62 MYOORA ROAD, TERRY HILLS – DA2023/1224

- 1.1 I refer to Council's letter dated 14 December 2023 requesting additional information in relation to the above-mentioned DA and the additional items raised at a meeting on 20 February 2024, internal and external referrals and the submissions received.

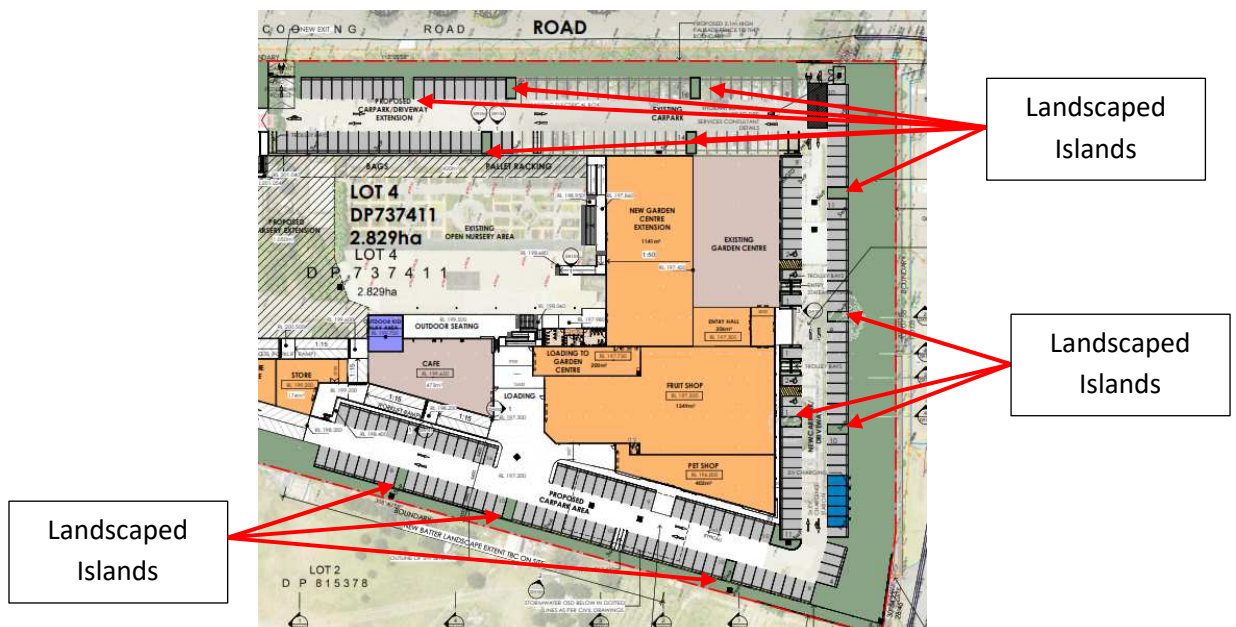
- The southern side setback to 279 Mona Vale Road is inadequate with respect to landscape treatment and is to be increased to a minimum of 6 metres to allow for greater planting.

1.9 As submitted the landscaping along the southern boundary provided a combination of 6 metres at the western end reducing to 3 metres at the eastern end. Currently on site there is no setback at the eastern end, this area contains the bulk storage bins which are aligned with the boundary. The provision of a 3 metre setback in this location is an improvement to the current site layout. This setback is proposed to be

retained, however the configuration along the southern boundary has been improved through the introduction of the following:

- Introduction of landscape islands, the width of a parking space within the southern carpark. 3 additional bays added, refer to diagram below.
- Introduction of a wider landscape zone to the southern boundary that provides a 8.4 metre setback.
- Retention of the 6 metre landscaped setback at the western end towards Myoora Road.

1.10 The proposed changes will enhance the relationship of the site with the southern property and significantly enhance the landscape setting.

Terrey Hills Community Bridle Trail

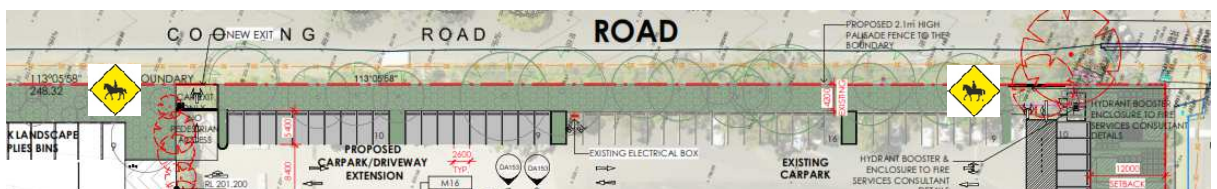
The proposed driveway works and the required kerb and guttering along Cooyong Road will impact upon the Terrey Hills Community Bridle Trail (which runs along the southern side of the road) during construction and ongoing use of the site. Demonstration of how the works will be managed during construction and how vehicular movements will be managed during operation of Flower Power with reference to the trail is required.

- 1.26 The Plan of Management will be prepared by the lead contractor prior to the commencement of any works. It is recommended that this form a condition of consent. Traffic Management will be required during construction to ensure persons / animals using the Trail and pedestrians will be safe. The Traffic Management will include controlled access and clear signage to minimise the potential impact. We acknowledge that there will be disturbance during construction, however this will be managed to ensure the conflicts are mitigated.
- 1.27 During operation, we see no difference with how the site currently operates. There is already an entry / exit point on Cooyong Road. Clear sight lines at the existing and one additional entry which necessitates tree removal will ensure the safety and visibility for riders.
- 1.28 There is one existing sign along the Cooyong Road frontage as shown below.

Configuration of uses – Original DA submission

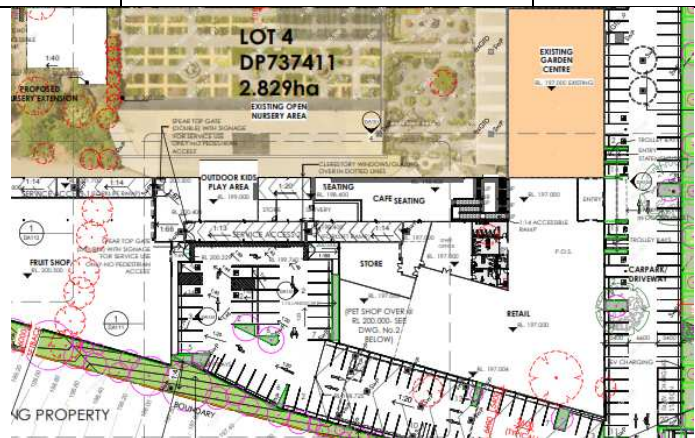
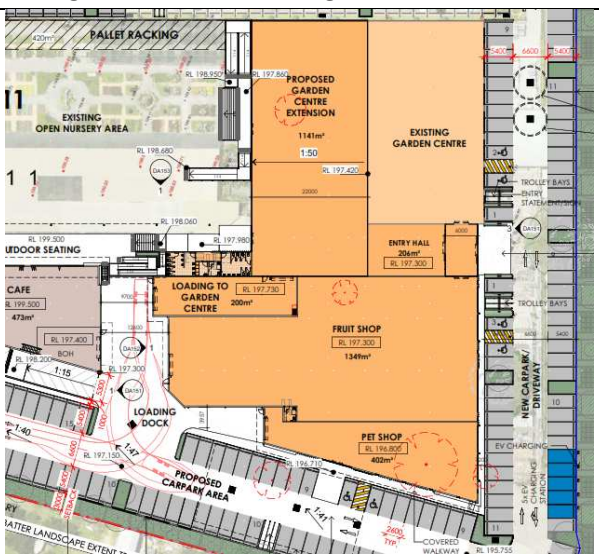
4.	Pedestrian routes between the carpark and the different uses within the building – as well as the spatial connections between these separate uses – could benefit from further consideration.	This feedback from the panel has led to the main change to the plan. The relocation of the pet shop and fruit and vegetable shop to the main elevation adjacent to the garden centre. This improves the connectivity between the uses and provides them all with the main frontage for ease of access. A pedestrian path has been added to the frontage of the new uses and southern parking area to connect with the garden centre. A comparison of the original DA and the amended DA configuration of uses is shown below:
